Access Compliance Report

Public Rights-of-Way

(Curb Ramps)

Intersection ID: 49929	Main Street: ASHBOURNE_HALL_RD	Cross Street: CHAMBERLIN_RD	Location: NW
ADA ID: F9BCAA8F0B64	Ramp Type: Perp	Initial Pass/Fail: Fail	Overall Compliance: No
Severity Score: 1.25			
Codes/Mitigation Info/Possible Solution		Field Measurements/Component Compliance

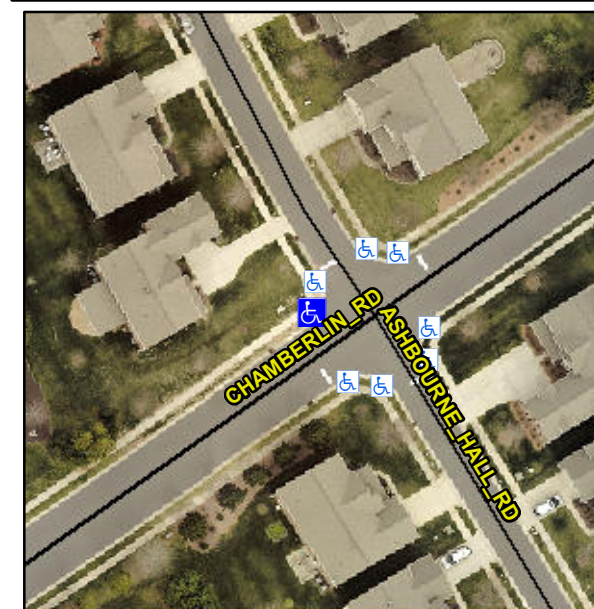
Not Found, R304.5.3

Compliance	Description	Data	Compliance	Description	Data
N/A	Ramp Length (in)	46.0	Yes	Ramp Slope (%)	7.7
Yes	Ramp Width (in)	48.0	No	Ramp XSlope (%)	3.6
N/A	Flare Type LT	N/A	N/A	Flare Type RT	N/A
N/A	Flare Slope LT (%)	N/A	N/A	Flare Slope RT (%)	N/A
N/A	Flare Traversable LT?	N/A	N/A	Flare Traversable RT?	N/A
N/A	Landing Length (in)	N/A	N/A	DWS Provided?	N/A
N/A	Landing Width (in)	N/A	N/A	DWS Contrast?	N/A
N/A	Landing Slope (%)	N/A	N/A	DWS Length (in)	N/A
N/A	Landing X Slope (%)	N/A	N/A	DWS Full Width?	N/A
N/A	Landing Curb? (Y/N)	N/A	N/A	DWS Offset (in)	N/A
N/A	Shared Landing?	N/A			
N/A	Gutter Ponding?	N/A	N/A	Gutter Slope (%)	N/A
N/A	Gutter Lip Ht (in)	N/A	N/A	Gutter X Slope (%)	N/A
N/A	Painted X Walk1?	No	N/A	Painted X Walk2?	N/A
	X Walk 1 Direction	To SE		X Walk 2 Direction	N/A
N/A	X Walk 1 Width (in)	N/A	N/A	X Walk 2 Width (in)	N/A
	X Walk 1 Slope (%)	2.4		X Walk 2 Slope (%)	N/A
	X Walk 1 X Slope (%)	3.1		X Walk 2 X Slope (%)	N/A

Remove & Replace Entire Ramp.
